COMMITTEE DATE: 21/04/2021

APPLICATION No. **20/02068/MJR** APPLICATION DATE: 13/10/2020

LOCATION: IORWERTH JONES HOME FOR THE ELDERLY,
TRENCHARD DRIVE, LLANISHEN, CARDIFF, CF14 5LJ

PROPOSAL: PROPOSED DEVELOPMENT OF 20 COUNCIL HOMES,
SUSTAINABLE DRAINAGE PROPOSALS, LANDSCAPE
PLANTING INCLUDING AN ECOTONE, AND
ASSOCIATED WORKS (AMENDED PLANS)

Street Scenes

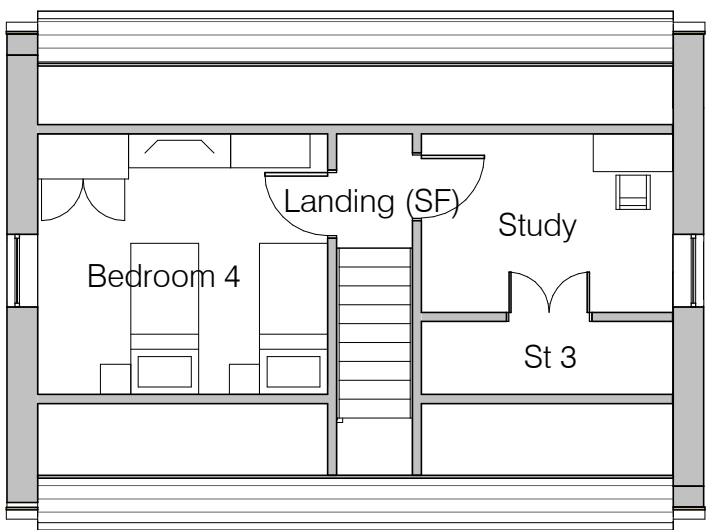
The streetscape elevations do not reflect the tree planting shown on the landscape strategy plan. Please review and update.
